April 12, 2021

40B 15 King St.

APRIL 12, 2021 SPECIAL ZBA MEETING MINUTES

Transportation Impact Assessment

PRELIMINARY
Building C Garage
& 1st Floor Plans

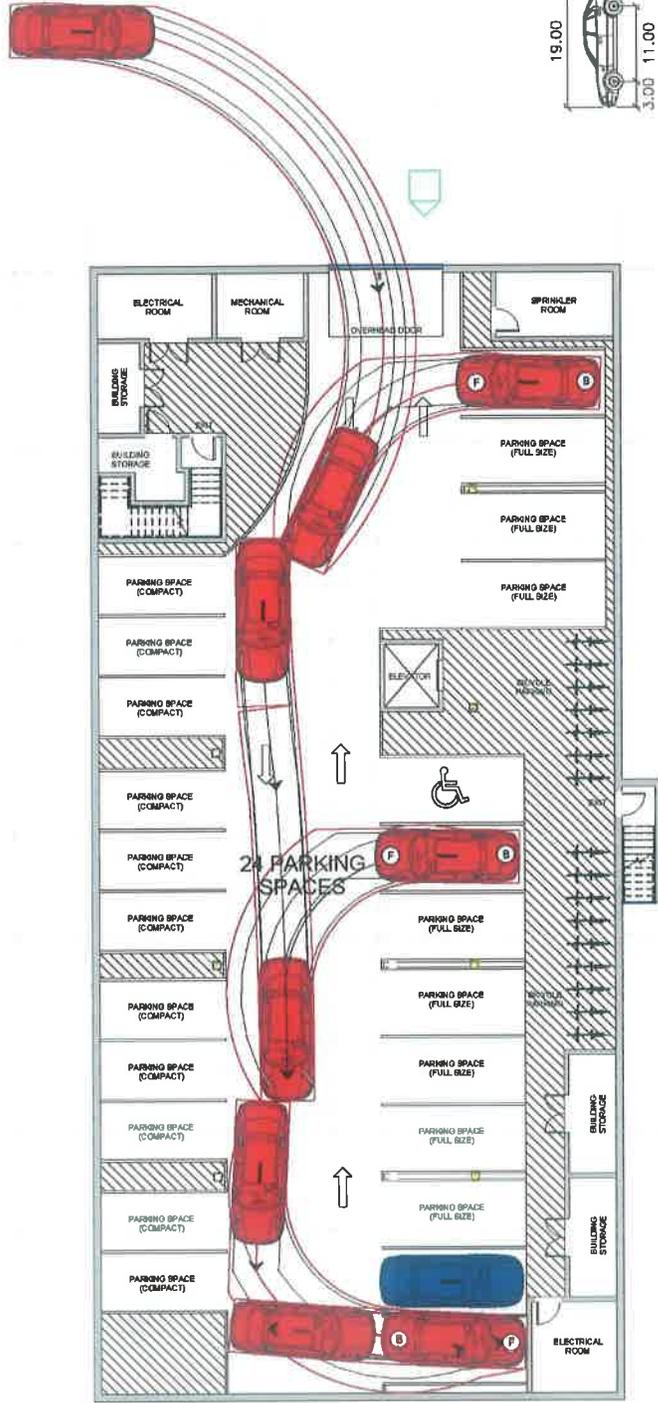
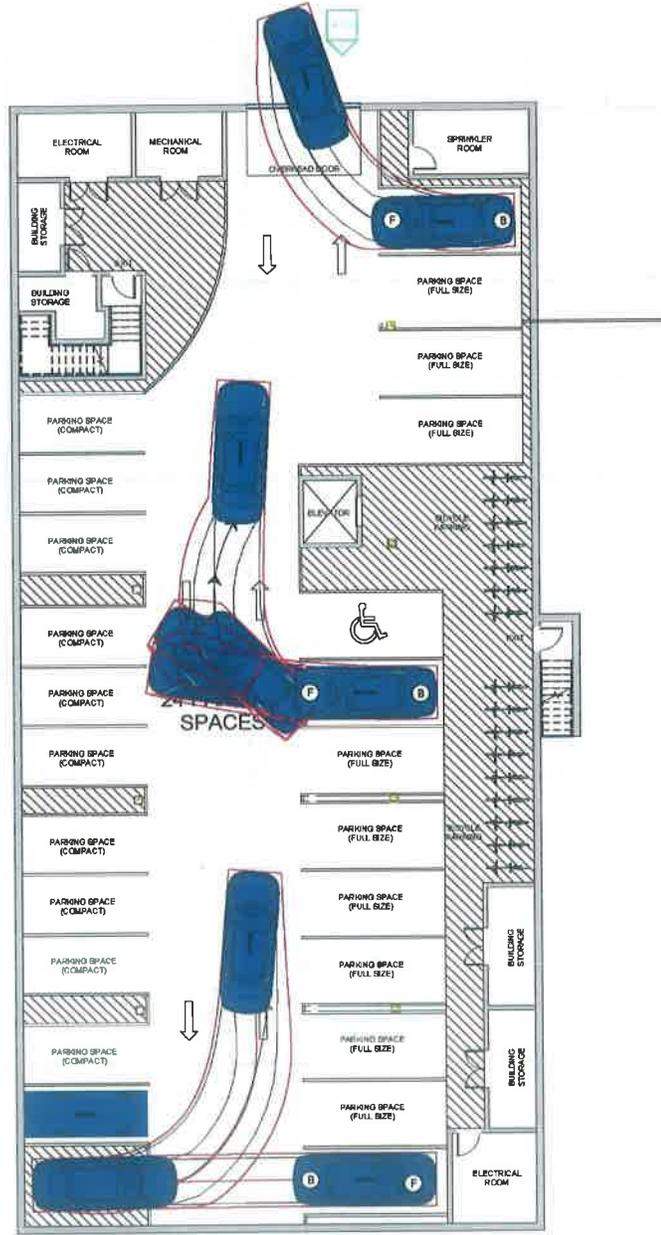
- Modifications to Garage parking circulation and access

DELIVERY TURNING MOVEMENTS 1

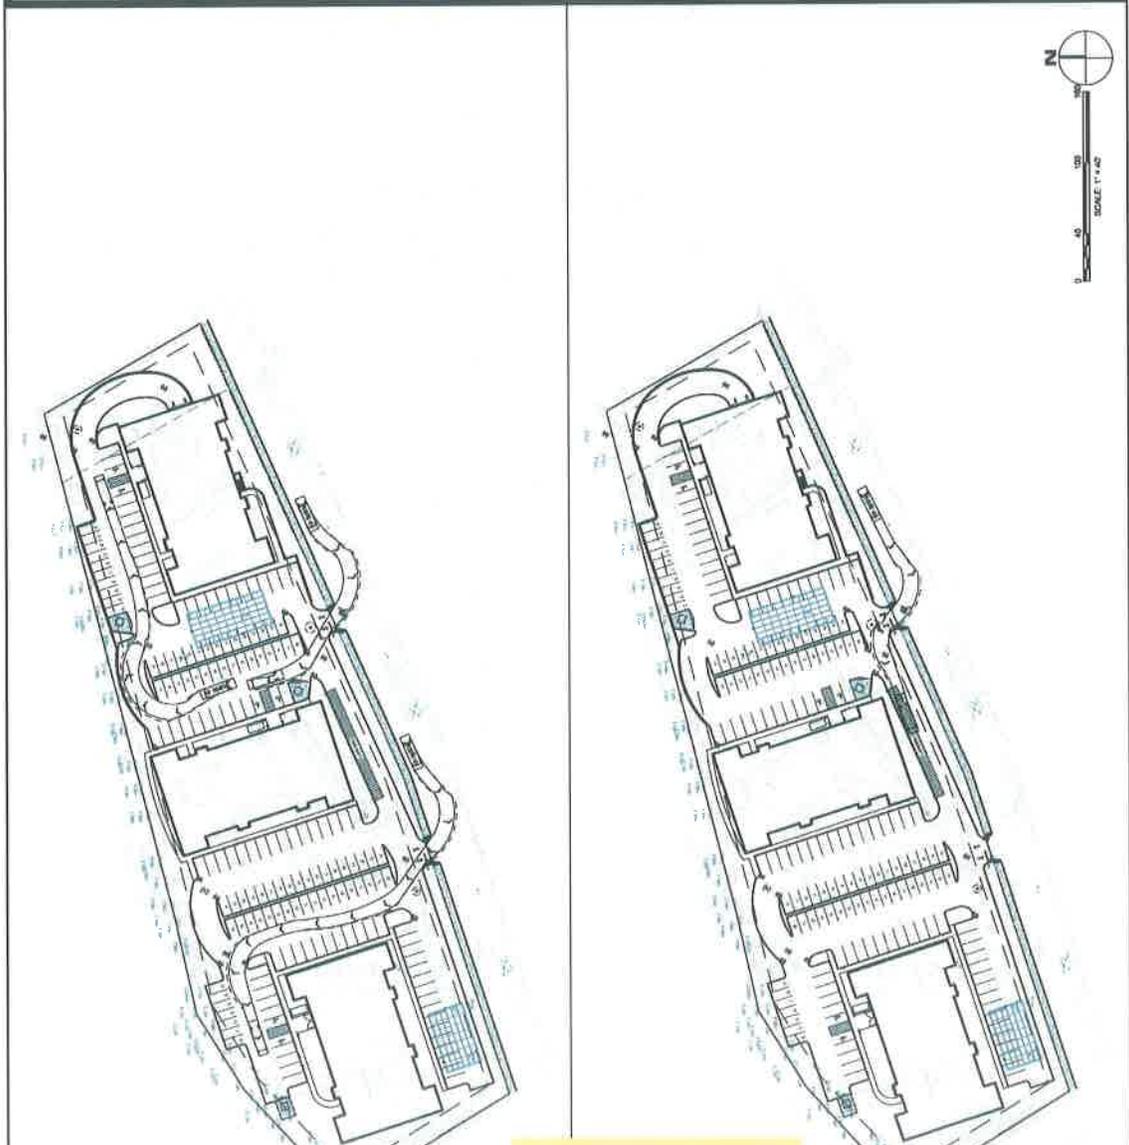
- Truck Turning Movements for Delivery, Fire, and Garbage Trucks
- Addresses Peabody Fire Department Captain Dowling's comments from ZBA hearing of October 5, 2020

DELIVERY TURNING MOVEMENTS 2

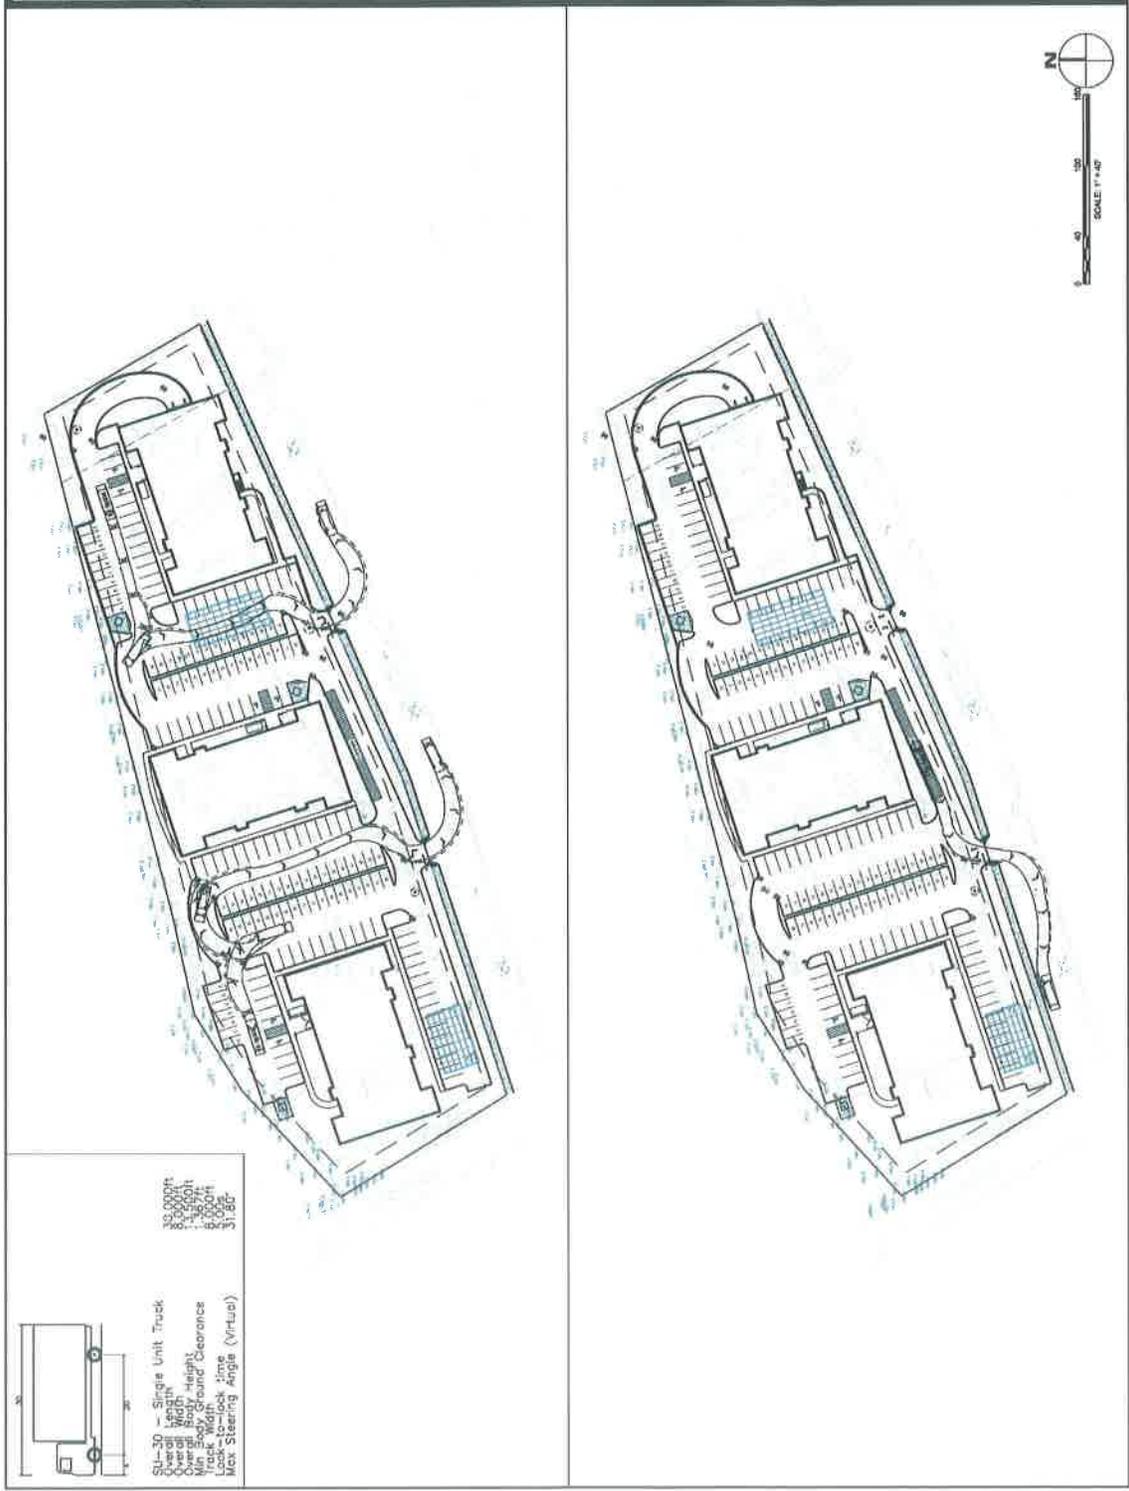
- Delivery Times scheduled for Off-Peak
- Sight Distance ensures adequate visibility for entering and exiting movements
